Report on Communal Entrance Door Repairs

Kingsway Gardens, Andover.

Block 1-4 York Court and Block 21-24 Tudor Court (One System)

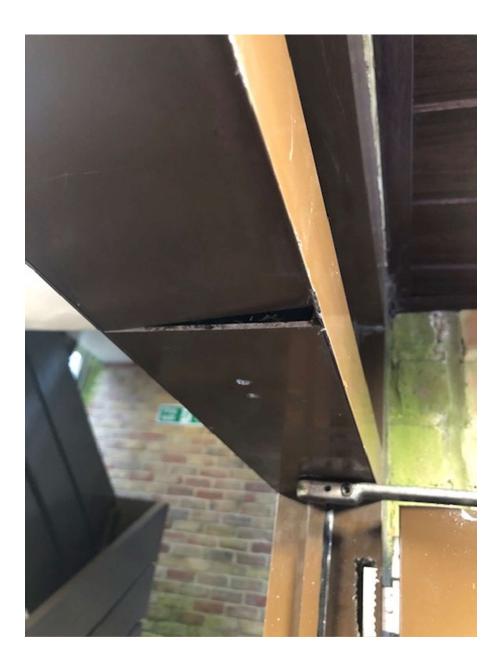
Door frame has had additional hinge fitted as door has dropped, damage to top of door frame. No thumb-turn present, relying on push to exit button. Glazing beads to door and side panels in poor condition. Panel to intercom in poor condition. Replace door and side panels.
